## **DEPARTMENT OF TRANSPORTATION**

**[Docket No. FAA-2022-1647; Project Identifier AD-2022-01379-T; Amendment 39-22438; AD 2023-10-02]**

### **Airworthiness Directives; Transport and Commuter Category Airplanes**

Final rule.

Figure 1 to paragraph (g)(1)(i)— *Fundamental Effective Isotropic PSD at Outside Interface of Airplane Antenna*

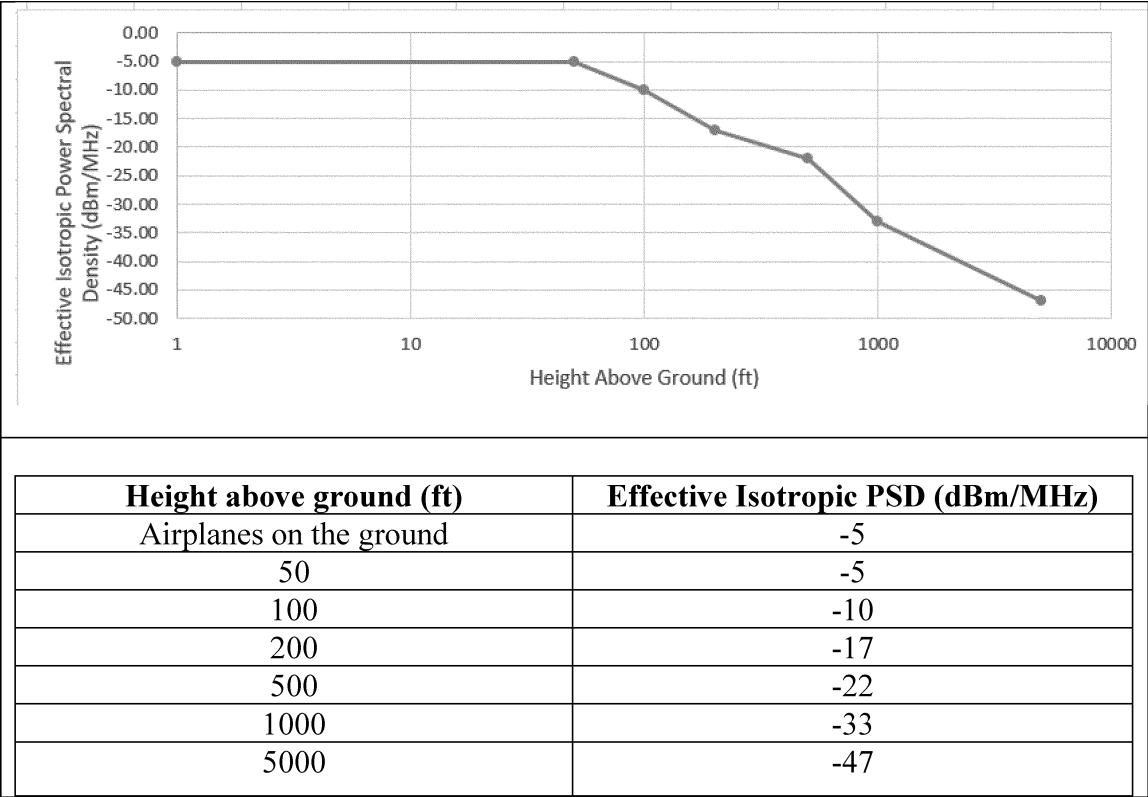
*Comment summary:* Textron Aviation requested the FAA clarify at what reference point the PSD requirements apply. The commenter stated it assumed that they apply at the radio altimeter receive antenna input, such that antenna characteristics, coax loss, and filter characteristics would be included in the determination.

*FAA response:* The FAA agrees and has changed the title of figure 1 to paragraph (g)(1)(i) of this AD to reflect that the PSD requirements apply at the antenna input to the radio altimeter, and that the figure applies to the outward facing side of the antenna.

Figure 2 to paragraph (g)(1)(ii)— *Spurious Effective Isotropic PSD at Outside Interface of Airplane Antenna*

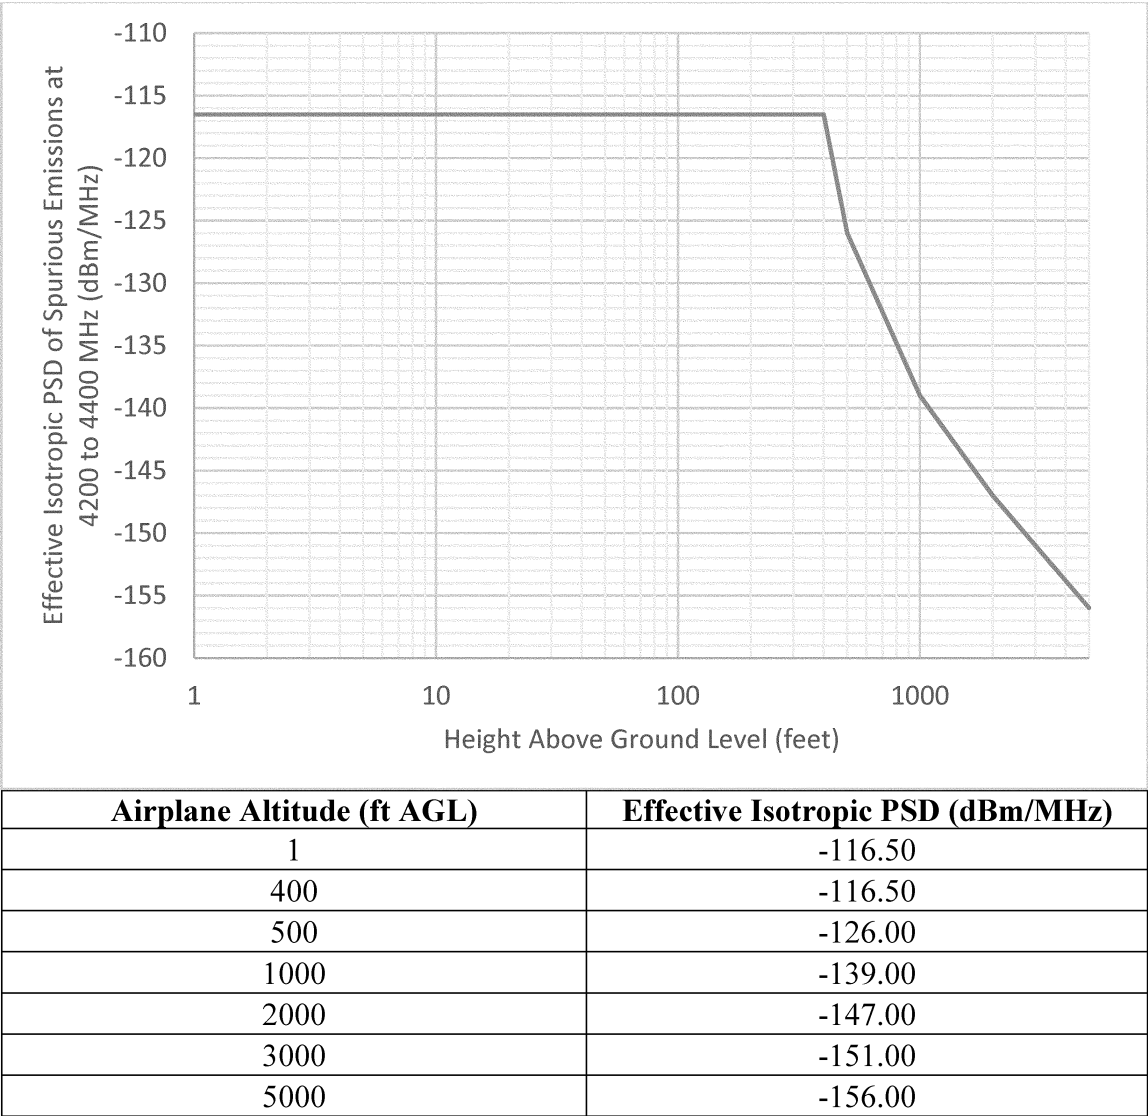
*Comment summary:* AIA requested that the FAA provide more information about the tolerances for determination of whether an airplane is radio altimeter tolerant. Several commenters requested that the FAA add a new figure indicating the spurious tolerance, similar to the figure with the PSD tolerance curve, and a specification of the altitude dependence for spurious tolerance.

*FAA response:* The FAA agrees and has replaced the proposed fixed emission level with a spurious PSD tolerance curve in figure 2 to paragraph (g)(1)(ii) of this AD. Subsequent figures have been redesignated accordingly.
